From: karen Buckingham
Sent: 18/10/2023 12:00:45 PM
To: Council Northernbeaches Mailbox; Gareth David
Cc: we t ireland
Subject: TRIMMED: Objection letter prepared on behalf of Palm Beach and Whale Beach Association - DA2023/1289 - 1112-1116 Barrenjoey Road, Palm Beach
Attachments: Objection letter 1112 1116 Barrenjoey Road Palm Beach DA2023.1289.pdf;

**Submission with regard to Development Application DA2023/1289
Demolition works and construction of Shop Top Housing
1112-1116 Barrenjoey Road, Palm Beach, NSW**

Figure 3 - 8.5 m height plane breach – note the scale of adjacent development along the Barrenjoey Road and the direct correlation with where the height breach starts to occur.

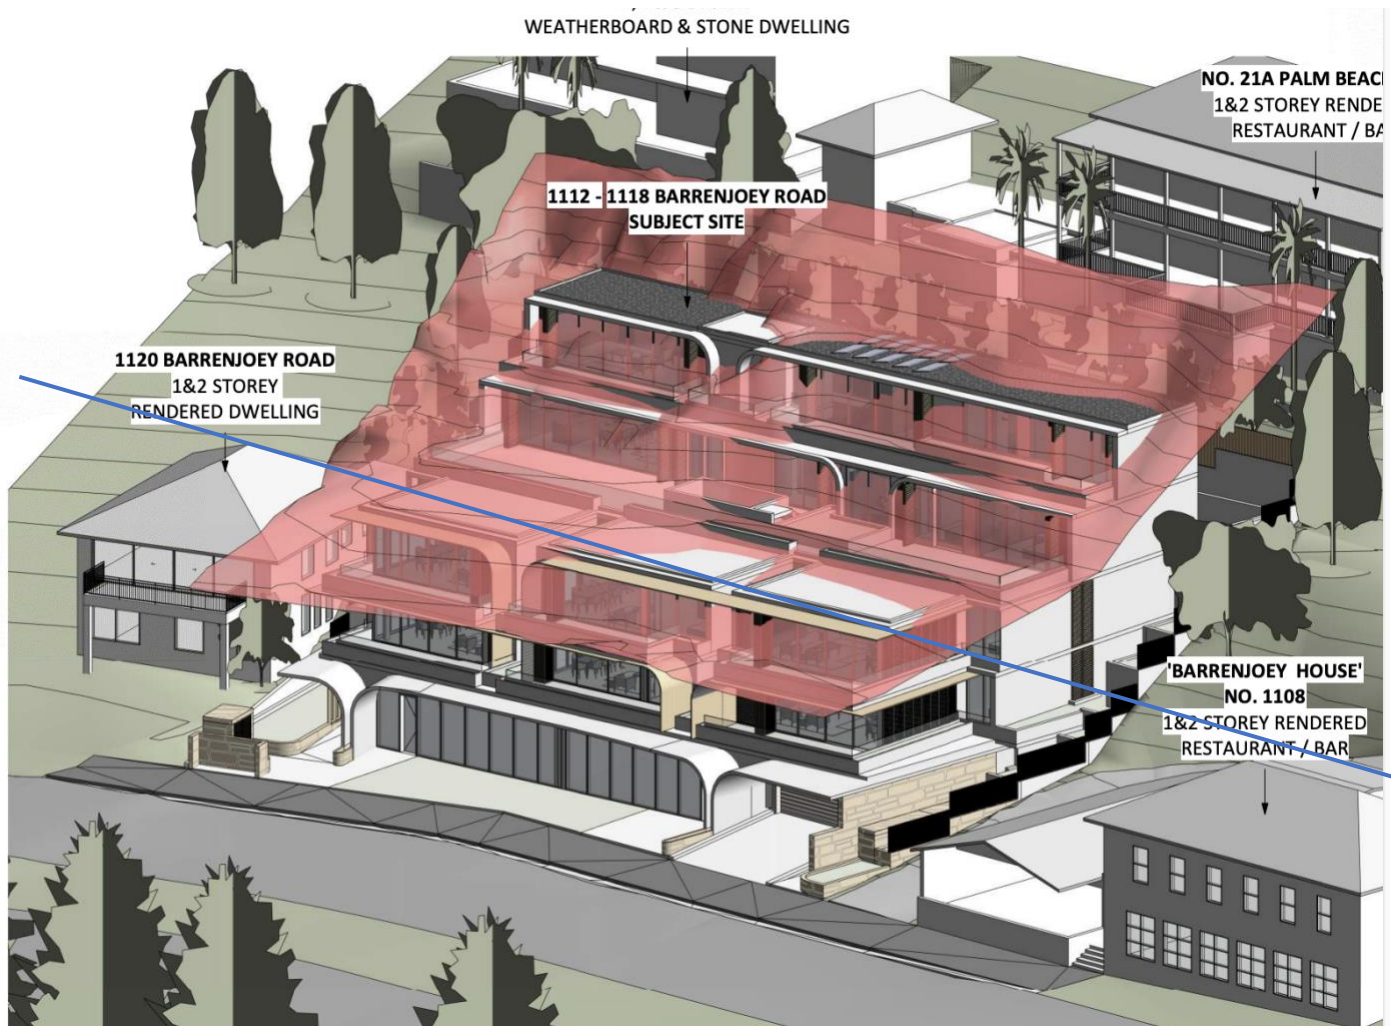
Comment: The proposed development fails to meet this objective, as already detailed in this objection and as shown in figures 3 and 4.

Clause 4.3 (2D) (a) - The height breach cannot be considered as minor. The submitted height plane diagrams demonstrate a breach of the maximum height limit at 3 of the 5 levels proposed (levels 2, 3 and 4). The top two levels have been recessed into the site and overhang the rear setback in an attempt to reduce the breach and give rise to additional impact on neighbouring amenity, visual impacts and building separation distances. A breach of the maximum height of buildings across 3 of 5 levels of a development cannot be considered as minor.

- Remove levels 3 and 4 from the proposed development and strictly comply with the 8.5 metre height limit.
 - Pull back the rear and side elevations of the proposed development to strictly comply with the ADG. 6-12 metre building separation distances are required.
